Zoning & Subdivision Committee
Thursday, July 10, 2014 11:45 am

1. Review of Jerome Village GPN-3 Final Plat (Jerome Township, Union County) –
Staff Report by Jenny Snapp

Staff Report – Jerome Village GPN-3

GLACIER PARK NEIGHBORHOOD SECTION 3

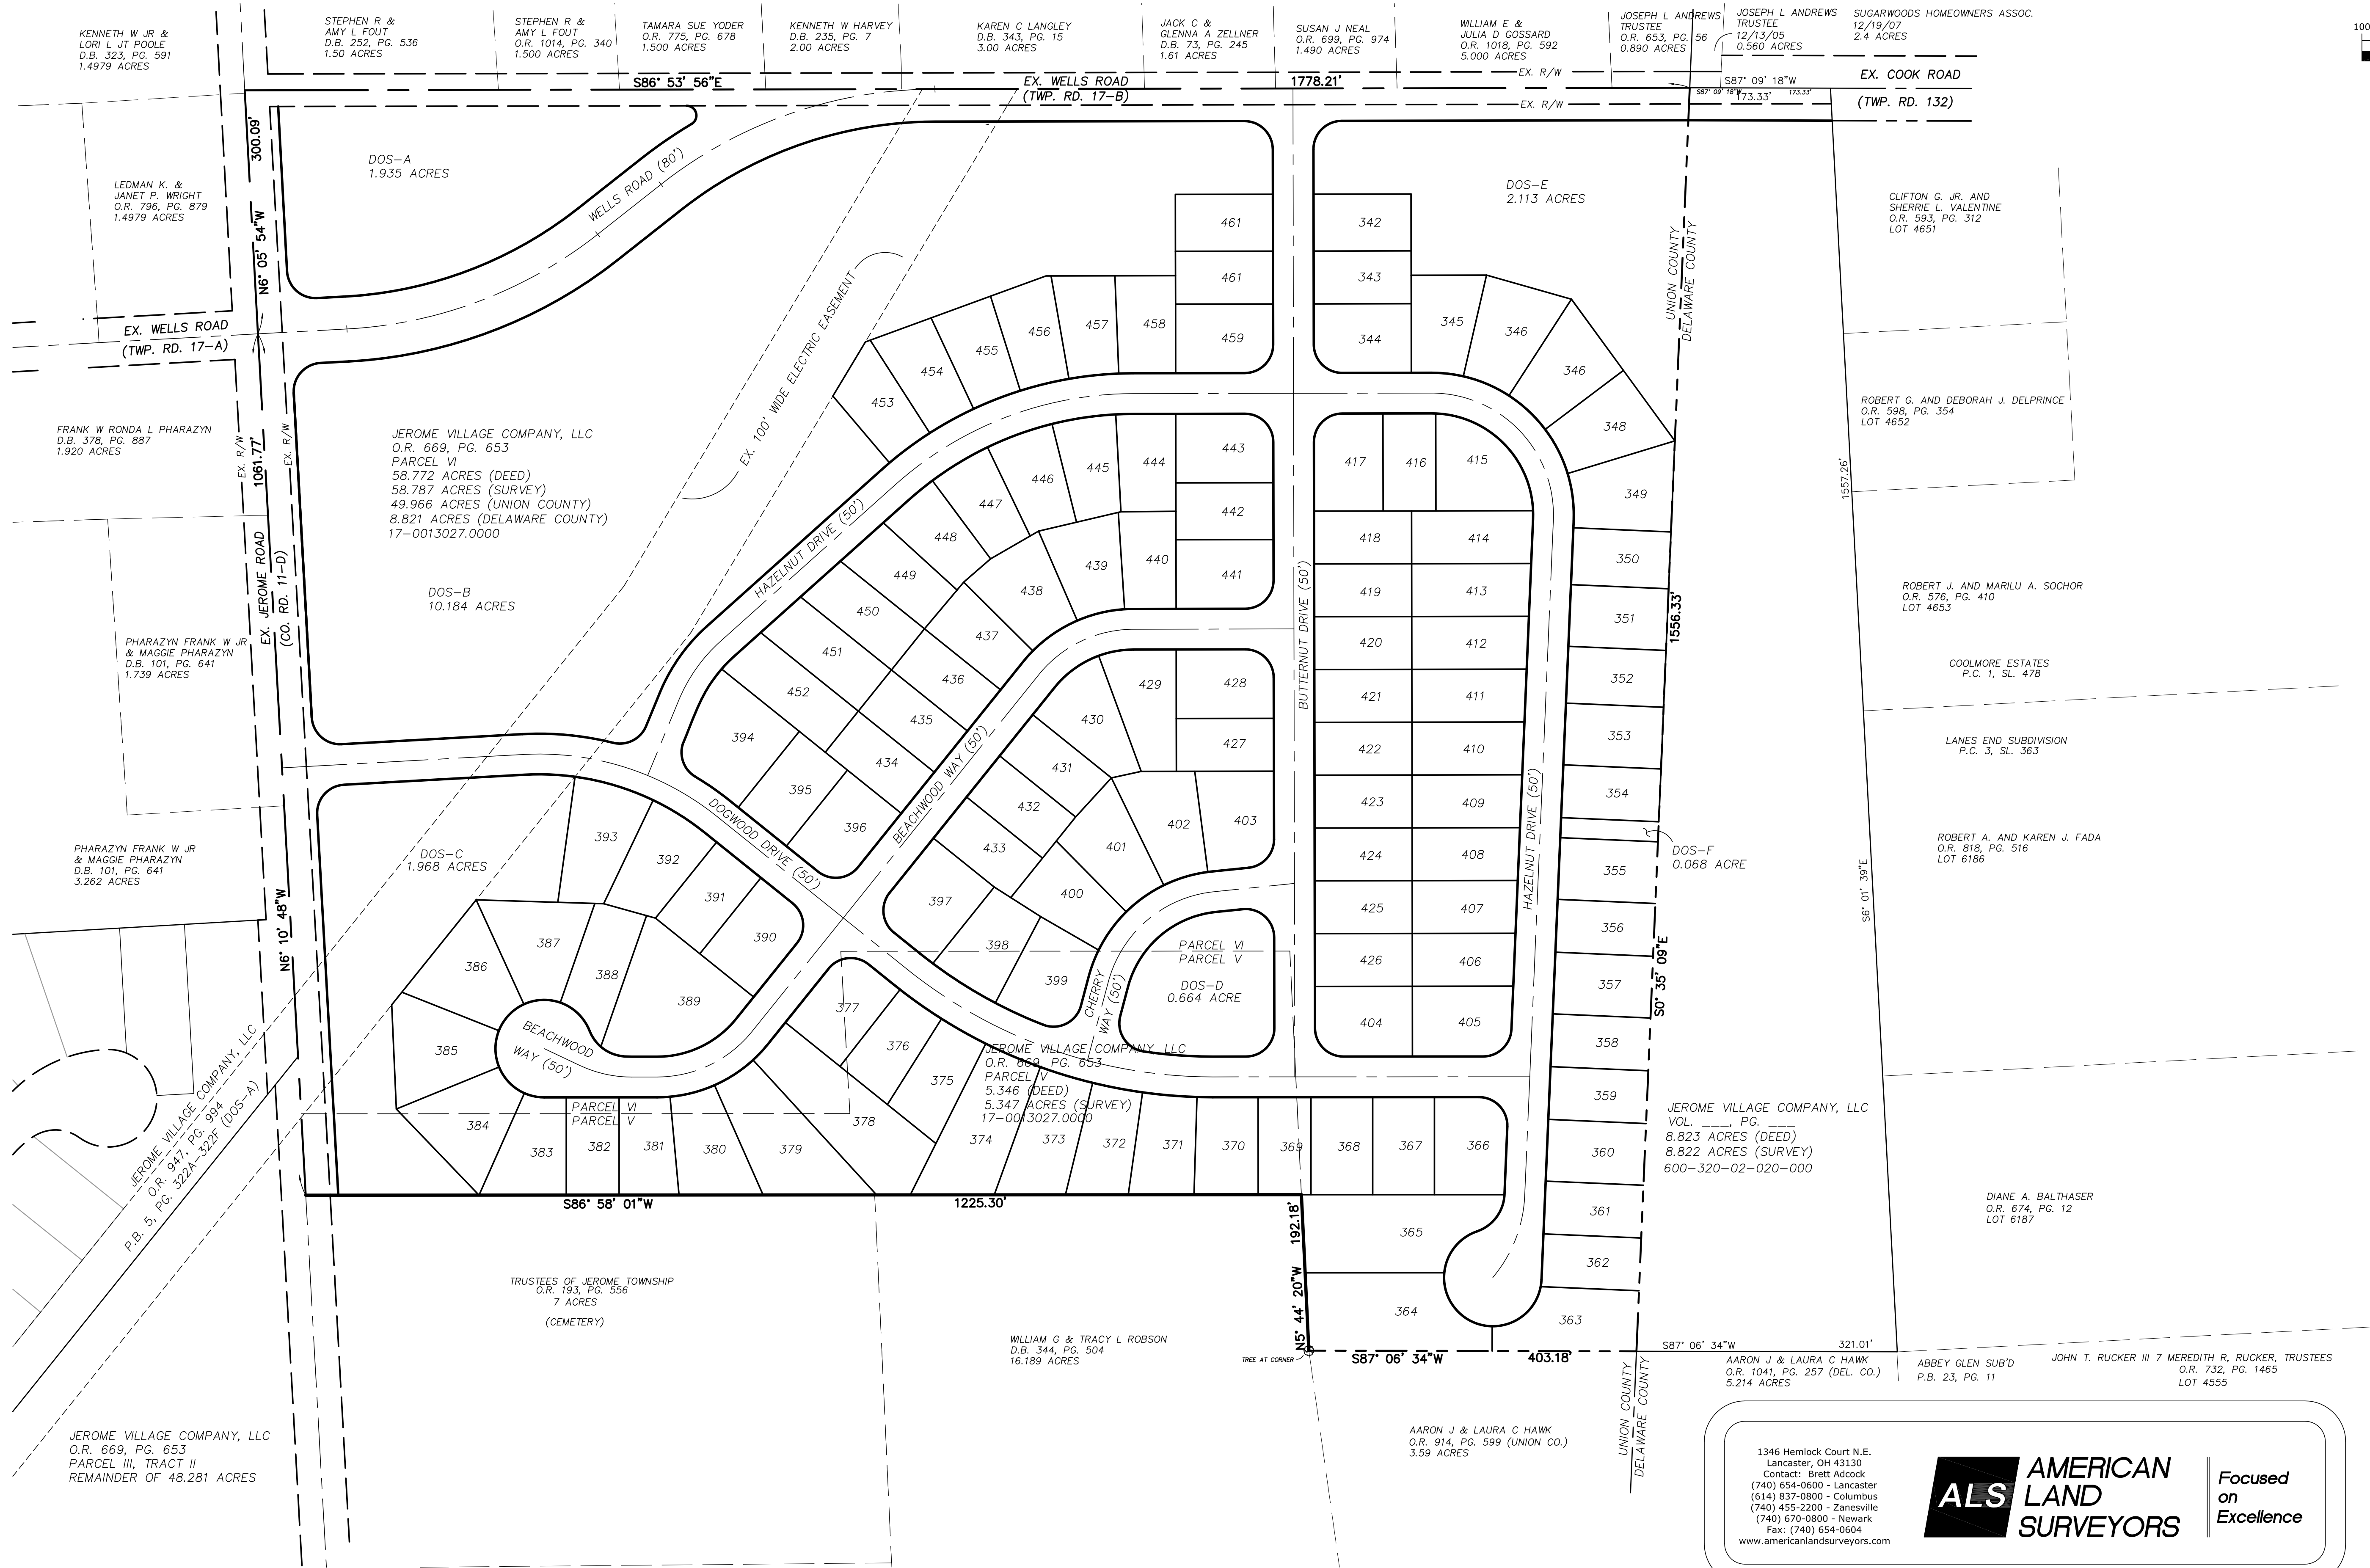
<p>1: the word "platting" is misspelled.</p> <ul style="list-style-type: none">✓ Sheet 1 (bottom left): The note regarding utility easements seems extremely specific in terms of easement widths and definitions. It also doesn't mention anything about drainage easements to Union County. Revision of this note should be considered.✓ Legend: An Icon should be added for pins set along the centerline of the roadway to the legend.✓ Add a drainage easement that encompasses the northern ditch from pond, p-151.✓ The volume and page of the appx. 8 Acre parcel in Delaware County should be noted on the Plat, with reference to the Delaware County Recorder's Office. Currently, it is blank.✓ Revise the 10 foot easement on the south side of Dogwood Drive to be a minimum of 20 feet for potential sanitary service extension.✓ Update the correct easement widths along Jerome Road for the waterline as mentioned by the City of Marysville.✓ Once the drainage easements are recorded in Delaware County, they will be required to be recorded with Union County as well. The same document can be used for this procedure. <ul style="list-style-type: none">• Union County Soil & Water Conservation District<ul style="list-style-type: none">○ No comments as of July 7, 2014.• Union County Health Department<ul style="list-style-type: none">○ Per an email dated July 2, the Union County Health Department submitted the following comments: <i>"All efforts should be made to provide a point of connection (via easements and/or service lines) to both water and sewer to any adjacent home, business or any other facility that is being serviced by a private water system (PWS) and/or sewage treatment system (STS)." In addition, "Any home or business that is currently being serviced by a private STS and ends up being situated within 200 feet of a sanitary sewer easement should be brought to the attention of the Union County Health Department." Further, "If at any time during the development of the subdivision a PWS (well, cistern, etc.) or STS is found, our office shall be</i>

- In an email dated July 3, 2014, the City of Marysville has minor technical items regarding GPN - 3 that shall be incorporated into the Final Plat Mylars for the July 10 LUC Meetings:
 - ✓ Sheet 1: The Utility Easement language should specifically mention "water lines" when describing the type of utilities that are permitted to be maintained within these areas.
 - ✓ Sheet 3: Per previous discussions with the developer, a twenty (20) foot utility easement (waterline) shall be provided across the developers entire Wells Road frontage.
 - ✓ Sheet 3: The nine (9) foot easement along Butternut Drive is in conflict with the easement language shown on Sheet 1 (ie. a minimum of ten/10 feet in width adjacent to all public roadways).
 - ✓ Sheet 5 & 6: Per the approved construction plans, the utility easement along the entirety of Jerome Road shall be twenty one (21) feet wide.

1. Miscellaneous Restrictions/Notes #28 on sheet 1, the word "platting" is misspelled.
2. The note regarding utility easements on sheet 1 (bottom left) seems extremely specific in terms of easement widths and definitions. It also doesn't mention anything about drainage easements to Union County. Revision of this note should be considered.
3. Add the icon for pins set along the centerline of the roadway to the legend.
4. Add a drainage easement that encompasses the northern ditch from pond P-151.
5. The volume and page of the ~8 acre parcel in Delaware County should be noted on the plat, with reference to Delaware County Recorders Office. Currently it is blank.
6. Revise the 10' easement on the south side of Dogwood Drive to be a minimum of 20' for potential sanitary service extension.
7. Update the correct easement widths along Jerome Road for the waterline, as mentioned by COM.

- **Sheet 1** - The Utility Easement language should specifically mention "water lines" when describing the type of utilities that are permitted to be maintained within these areas.
- **Sheet 3** - Per previous discussions with the developer, a twenty (20) foot utility easement (waterline) shall be provided across the developer's entire Wells Road frontage.
- **Sheet 3** - The nine (9) foot easement along Butternut Drive is in conflict with the easement language shown on Sheet 1 (i.e. a minimum of ten (10) feet in width adjacent to all public roadways).
- **Sheet 5 & Sheet 6** - Per the approved construction plans, the utility easement along the entirety of Jerome Road shall be twenty-one (21) feet wide.
